**STAFF RECOMMENDATION**

**1707 Ashwood Avenue**

**February 17, 2021**

**Application:** New Construction—Addition; Partial Demolition

Figure 1. 1707 Ashwood Avenue, February 2021.

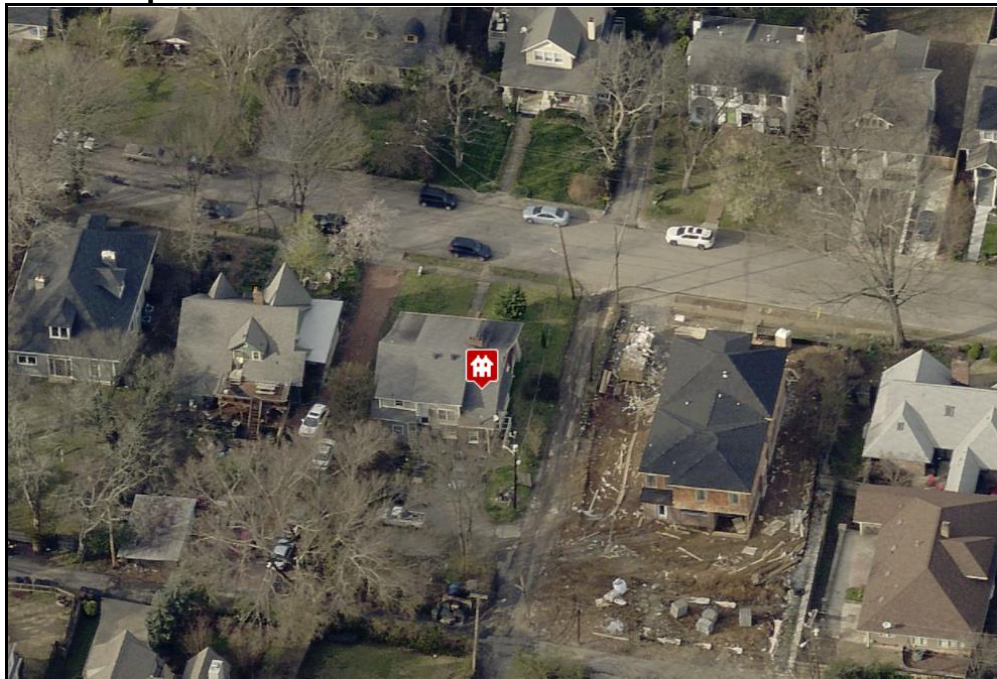
**Background:** The house located at 1707 Ashwood Avenue is a c. 1915 bungalow that contributes to the historic character of the Belmont-Hillsboro neighborhood (Figure 1).

Figure 2. Window to be removed.

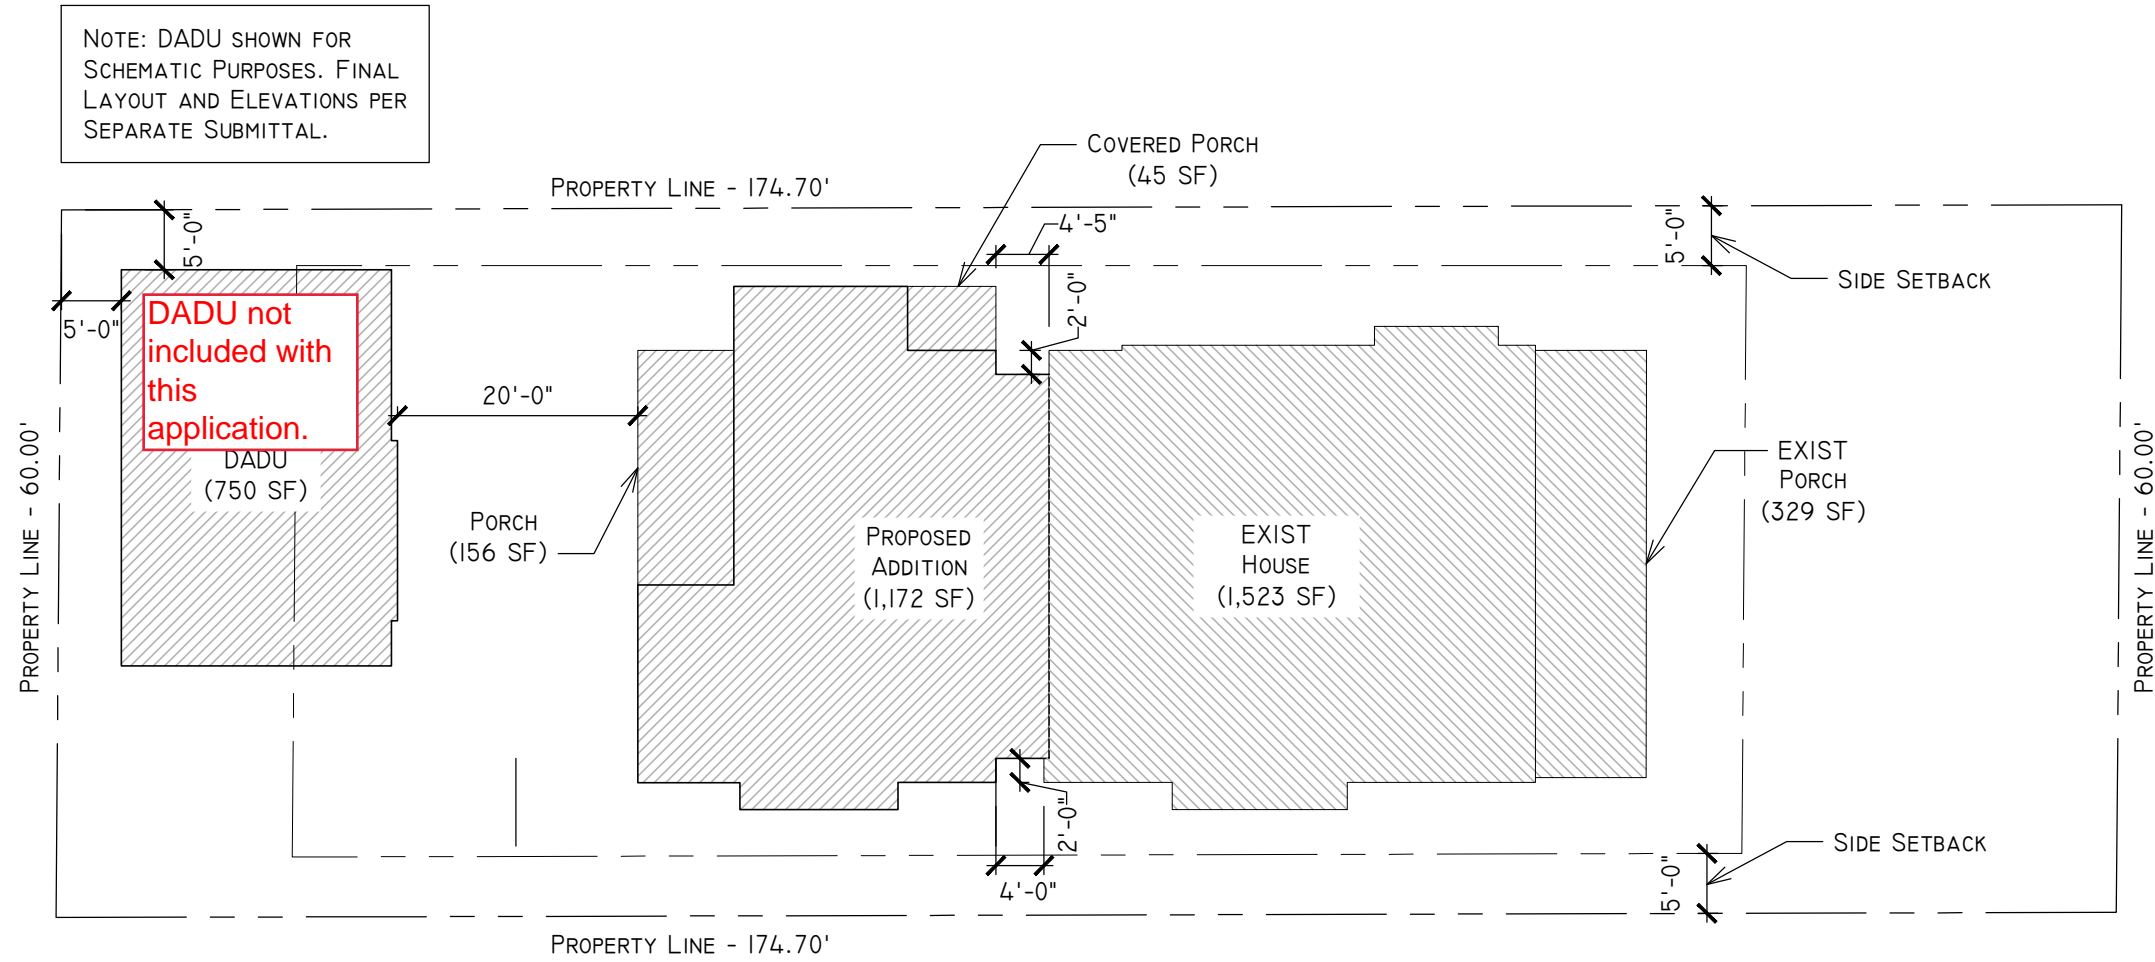
**Demolition:** The application includes removing a window on the left-side façade at the rear (Figure 2). Staff finds that removal of this window can be appropriate given its location beyond the midpoint and behind the projecting bay. For these reasons, staff finds that demolition of this opening does not meet Section V.1 for inappropriate demolition and can meet Section V.2 for appropriate demolition.

SITE  
 PLAN  
**01**

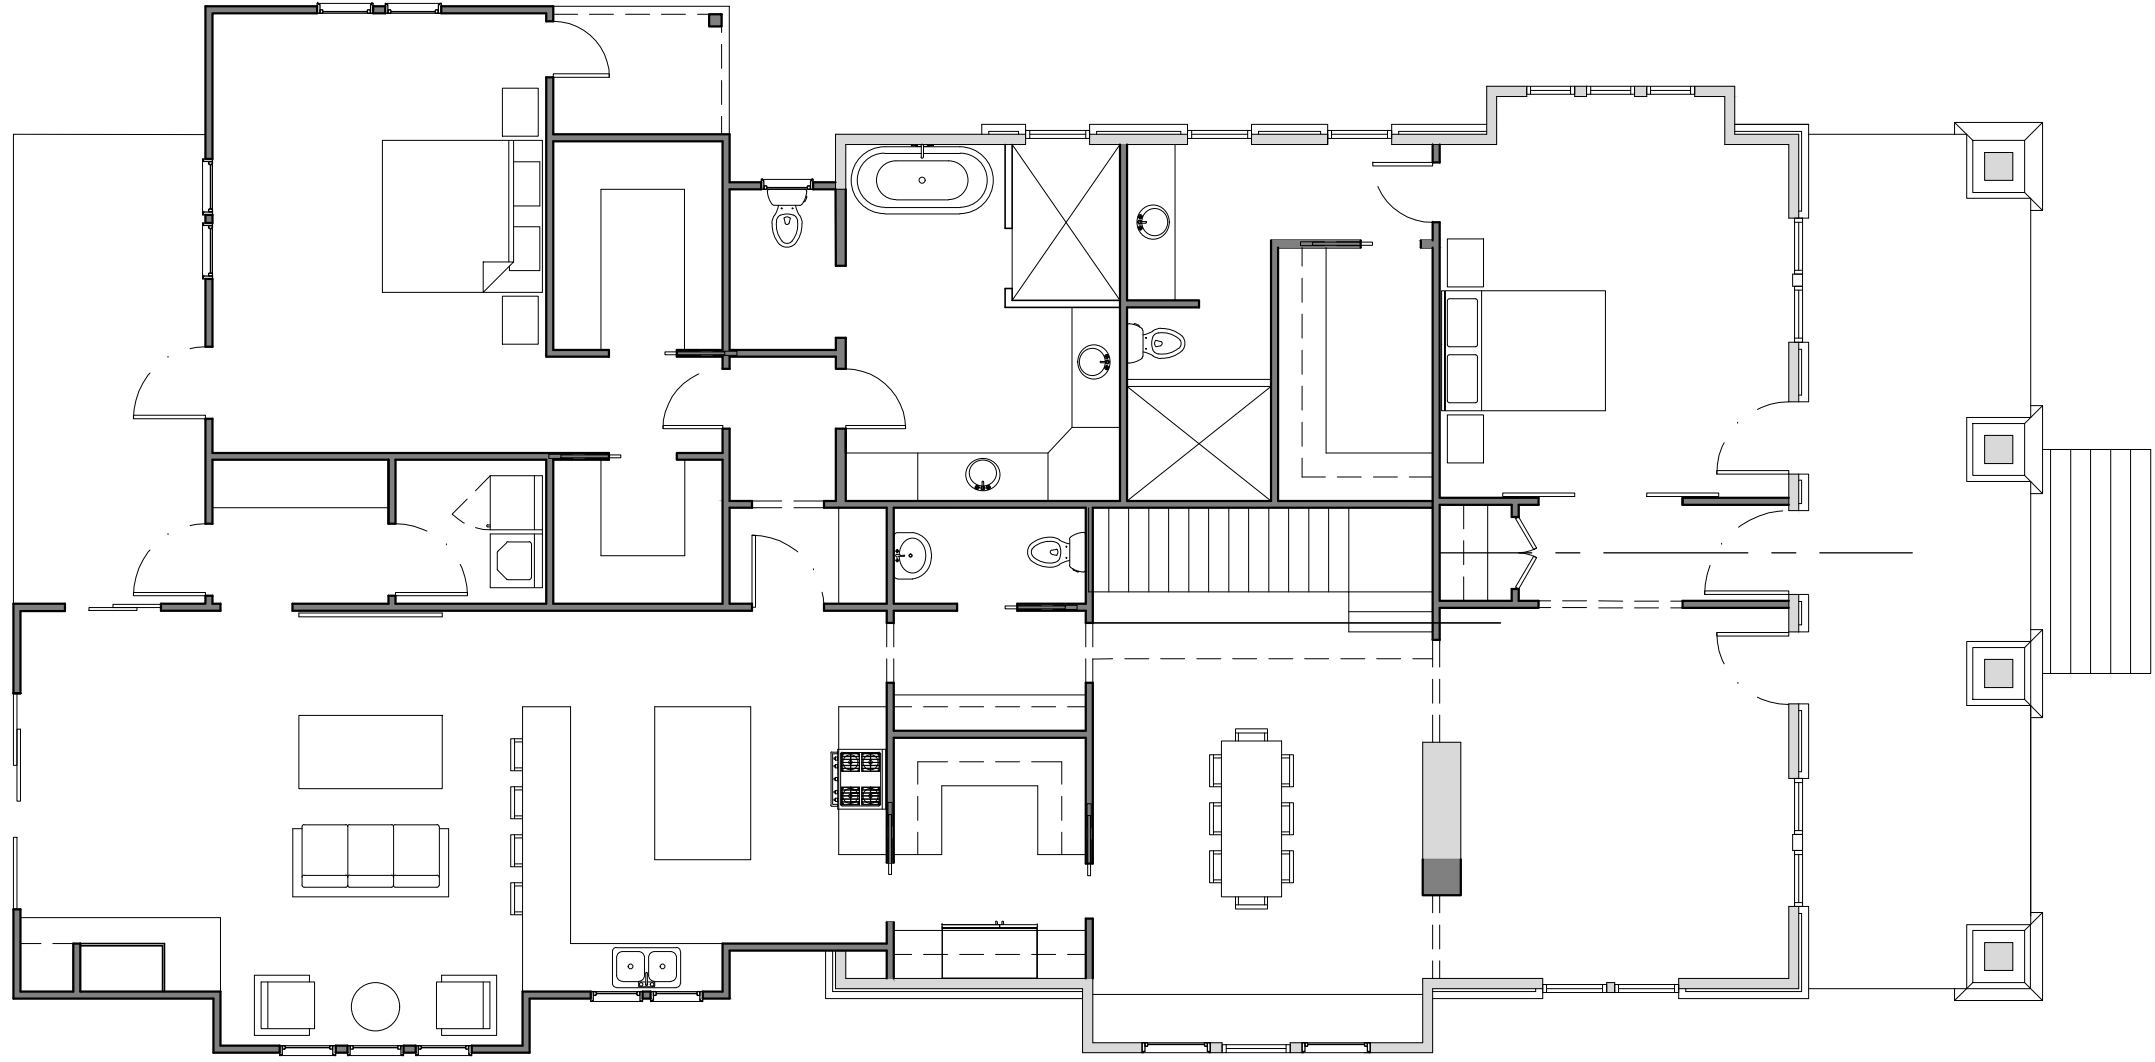
Setback & Rhythm of Spacing: The addition meets all base zoning setbacks. The new construction is six feet, six inches (6'-6") from the right property line; eight feet, eight inches (8'-8") from the left property line; and forty-eight feet (48') from the rear property line.

SCHEMATIC  
 ROOF PLAN

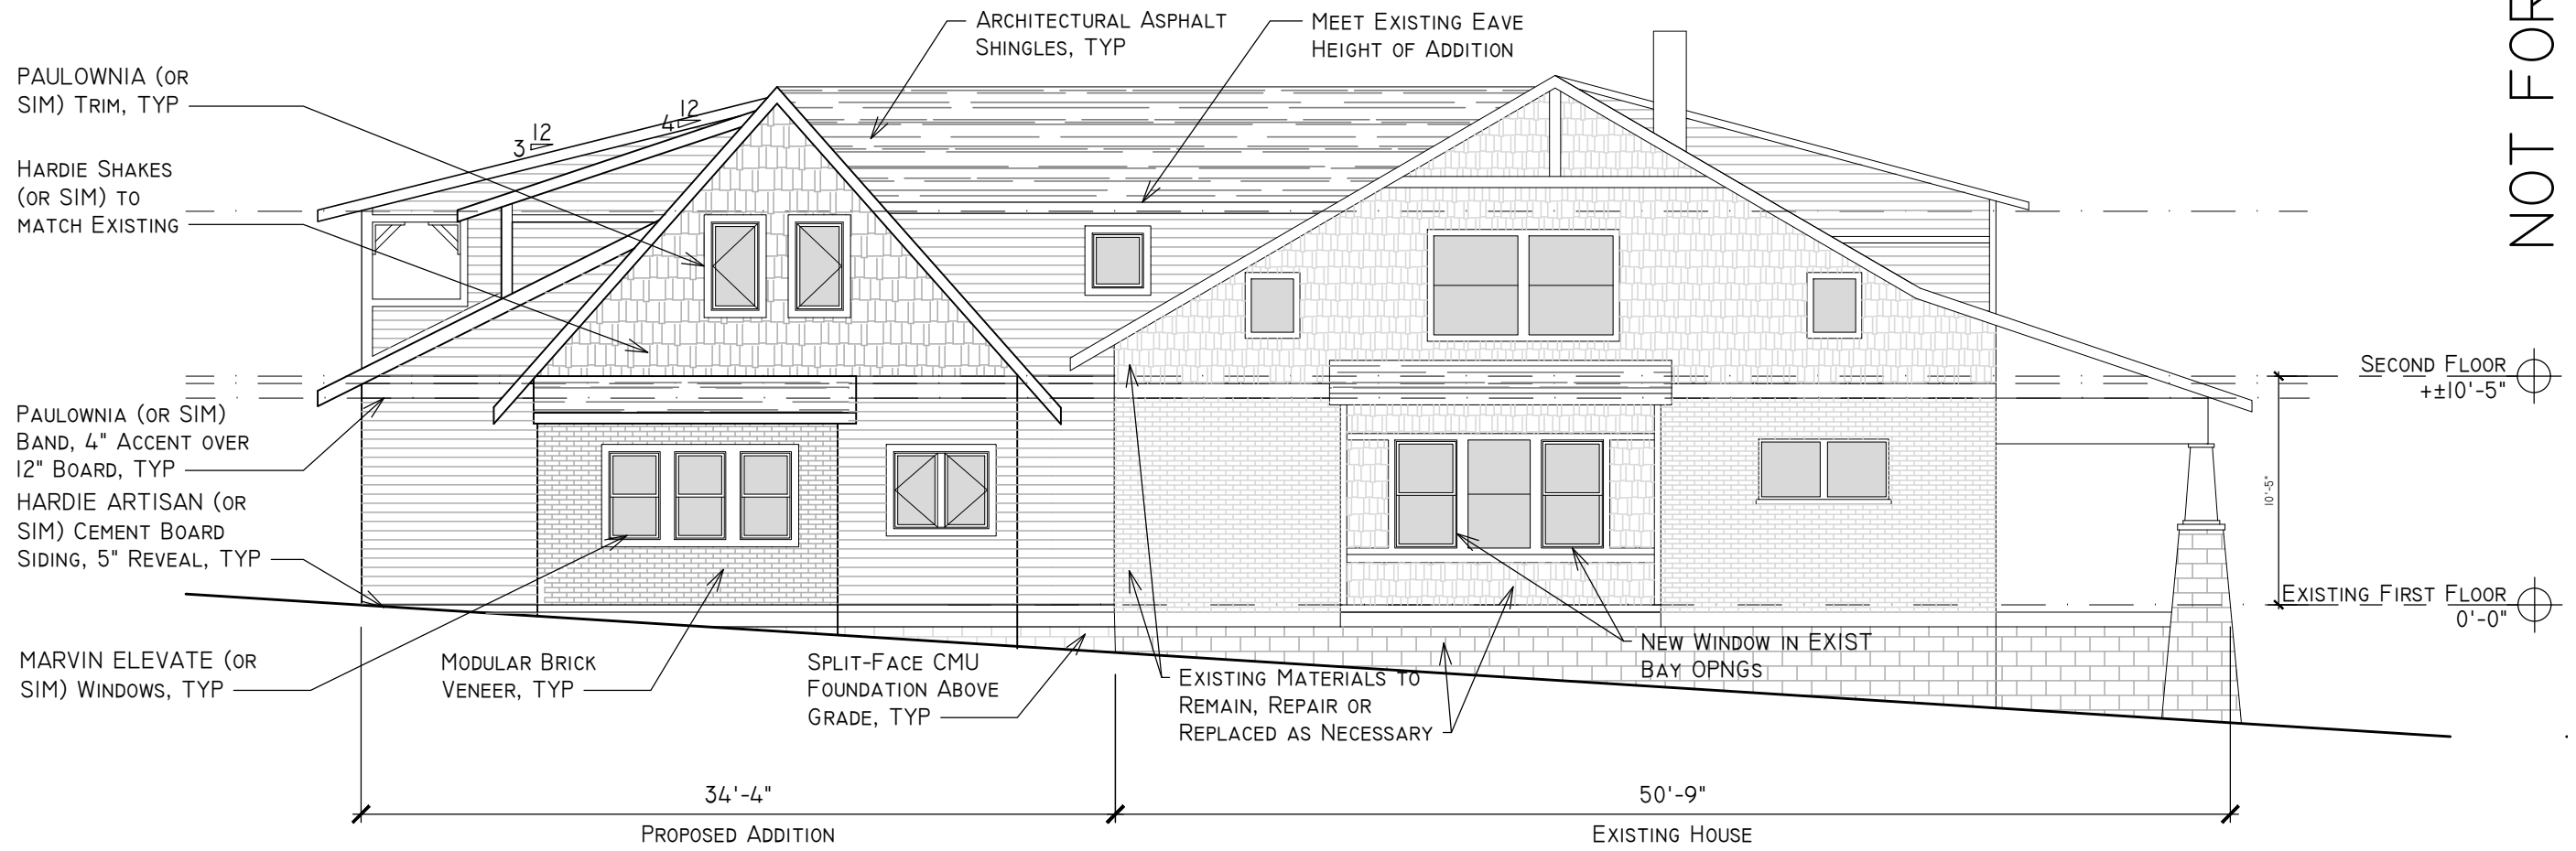
**Roof form:** The addition has a side gable roof form with a 14/12 pitch and incorporates shed dormers on the rear façade. Two rear balconies are incorporated on the rear façade, and both are located completely under roof. Staff finds that the roof forms of the addition are compatible and do not contrast greatly with that of the historic house.
